DESIGN/DEVELOPMENT REVIEW COMMISSION
DESIGN REVIEW DISTRICT
HISTORIC AGENDA
EVALUATION SHEET
Case #3

ADDRESS: 17 Gibbes Court

NATURE OF REQUEST: Request for a Certificate of Design Approval for exterior changes/new construction.

Views showing interior damage and structural issues of existing garage

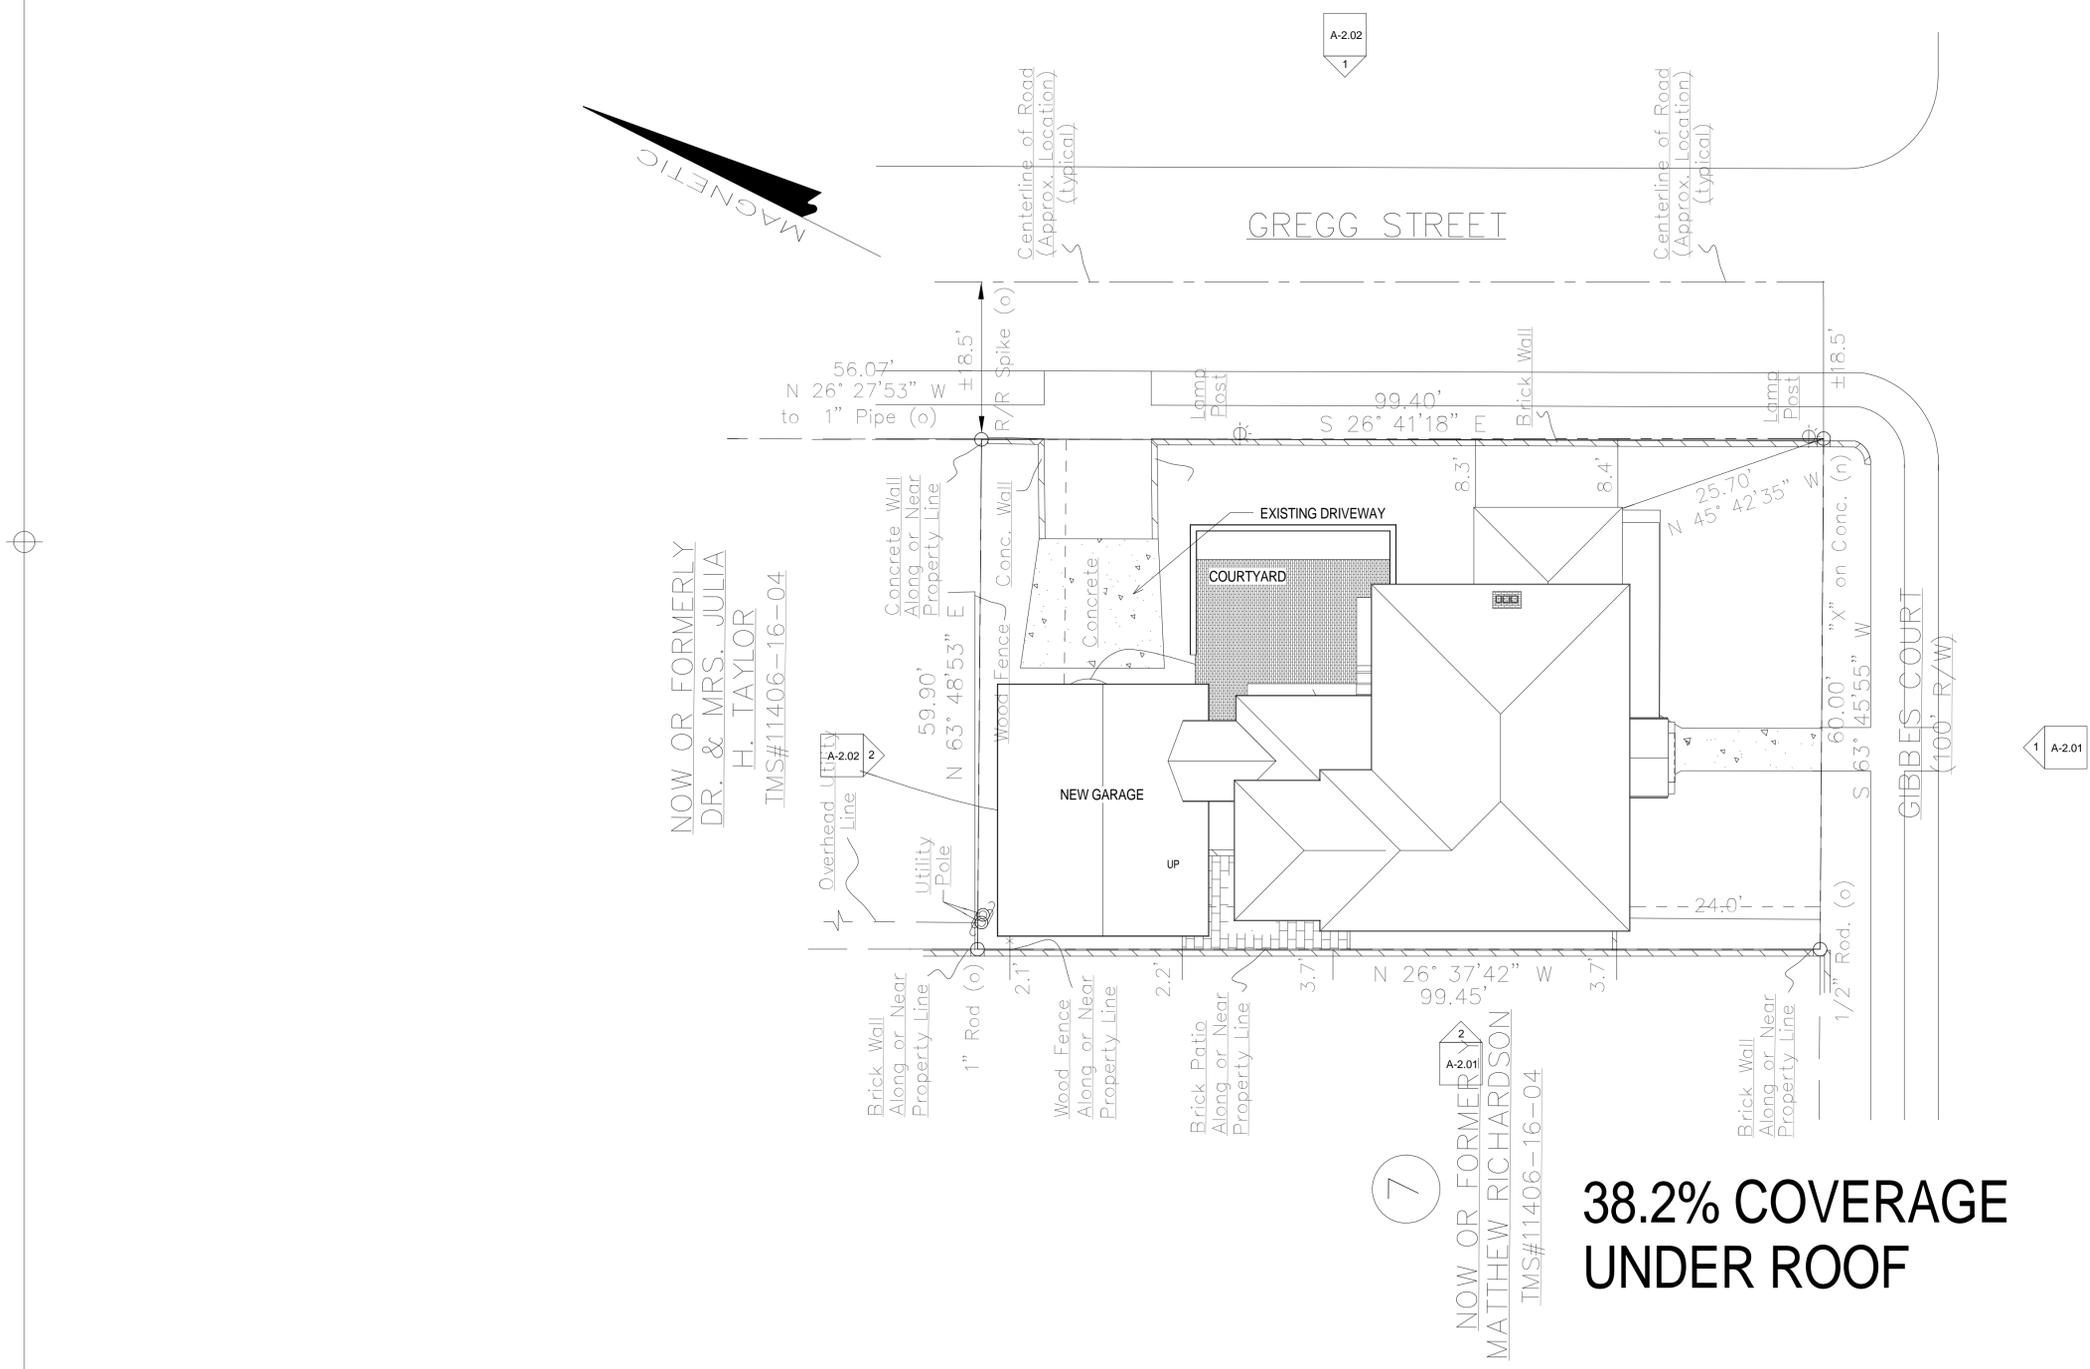
The applicant's proposal includes rehabilitating the existing house by repairing all existing historic architectural features including windows, doors and columns. A non-historic aluminum cornice system that is currently covering the exposed rafter tails in the eaves will be removed. The applicant is also proposing a 452 square foot addition on the rear, a new brick garden wall, and a new two-bay garage. An existing 1-story two-bay garage will have to be demolished in order for the new garage to be built. The existing garage has water and termite damage and is not structurally stable.

DRAWING NO:
A-2.01

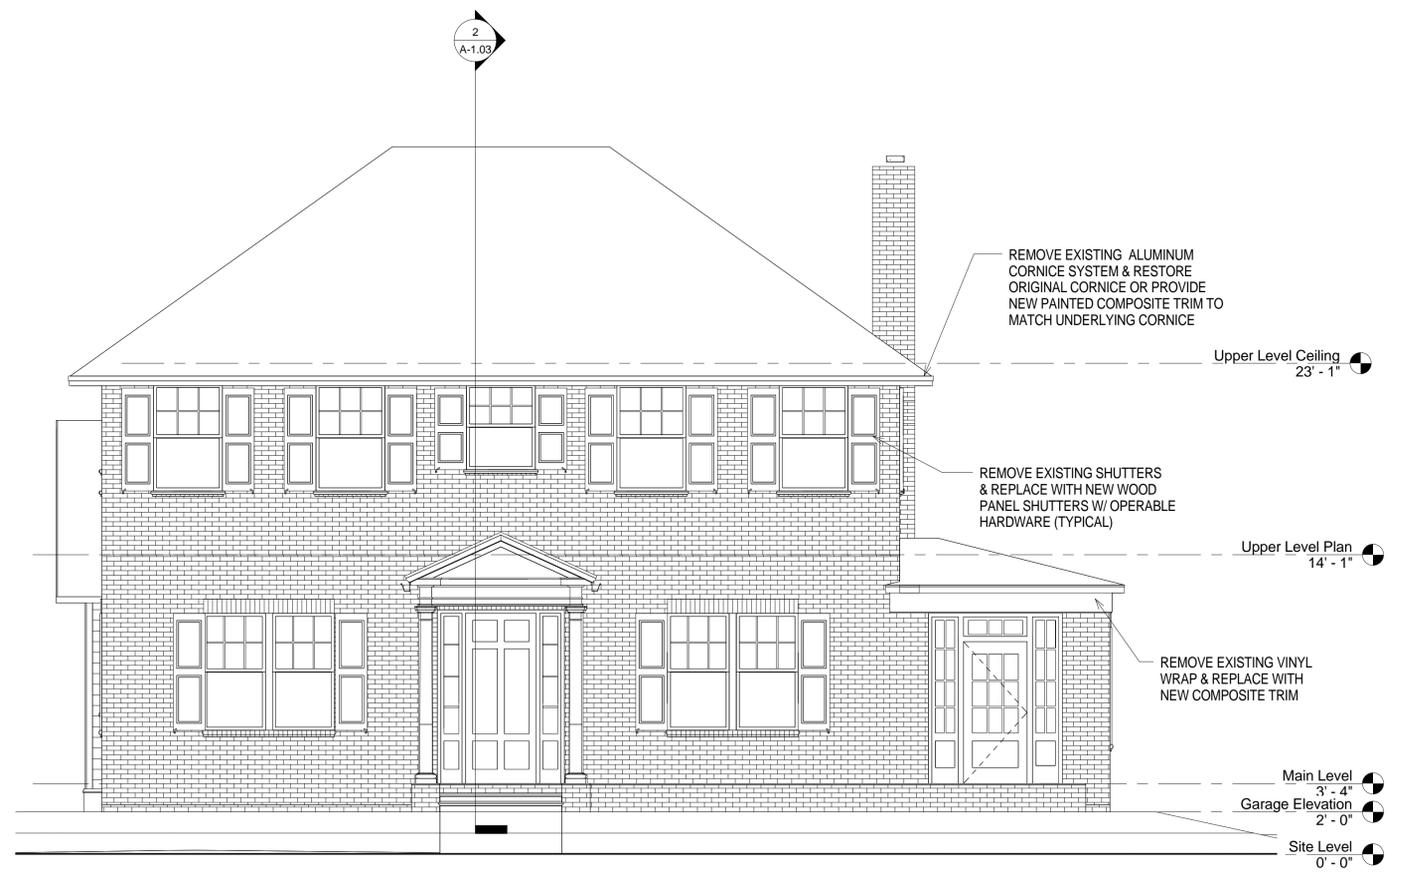
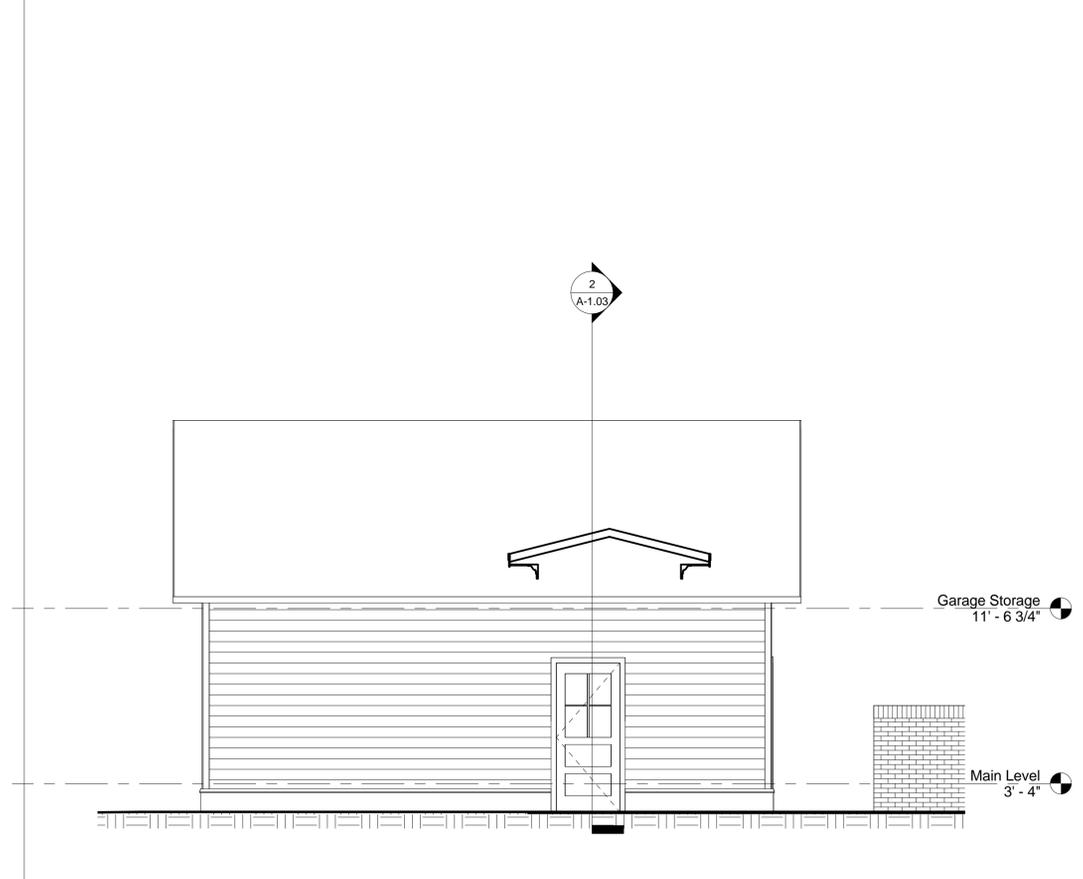
Chimneys: The elevations only show one chimney; however, the house has two brick chimneys. Staff recommends retaining, repairing and reflashings these chimneys as necessary.

Foundation: The elevations do not specify the material for the foundations of the addition or the garage. Staff recommends a brick foundation to match the existing historic brickwork, and a skirt board to be consistent with other wood sided buildings in the district.

- Both chimneys shall be retained, repaired and reflashed as necessary
- The exposed rafter tails in the eaves shall be repaired after the non-historic aluminum cornice system is removed
- The historic wood windows in the original portion of the house shall be retained and repaired
- The new windows in the addition and the garage shall be wood or aluminum-clad with exterior muntins to match the existing historic windows.
- The addition and garage foundations shall be brick to match the historic brickwork on the original portion of the house.
- All details deferred to staff
